LASER INTERFEROMETER GRAVITATIONAL WAVE OBSERVATORY  
- LIGO -  
CALIFORNIA INSTITUTE OF TECHNOLOGY  
MASSACHUSETTS INSTITUTE OF TECHNOLOGY

**Document Type** LIGO-M000154-A - D May 22, 2000

**Technical Evaluation of Alternative  
Design Concepts for the LIGO-II Seismic  
Isolation System**

Technical Advisory Group:

Figure 1: Total Weighted Scores

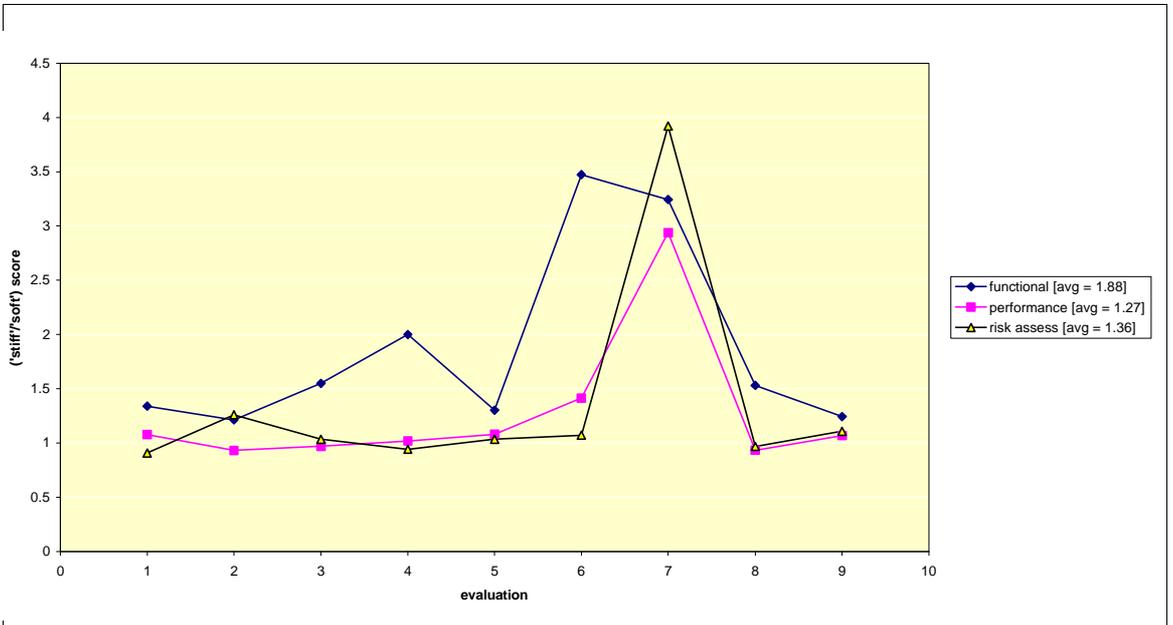
Nine of the ten TAG members used the criteria defined in the reference cited above to complete an evaluation matrix. The relative importance of each criterion was judged by individual evaluators by assigning a numerical weight to the factor and then scoring each design option against that criterion. Then for each criteria factor, members gave scores for each of the designs. The weighted total evaluation scores are shown in Figure 1. In this figure the curves labeled ‘soft’ and ‘stiff’ represent the score relative to a perfect score of unity. The curve labeled ‘stiff/soft’ is the ratio of the ‘stiff’ score to the ‘soft’ score for each evaluator. The TAG unanimously rates the ‘stiff’ system above the ‘soft’ system when all factors are considered.
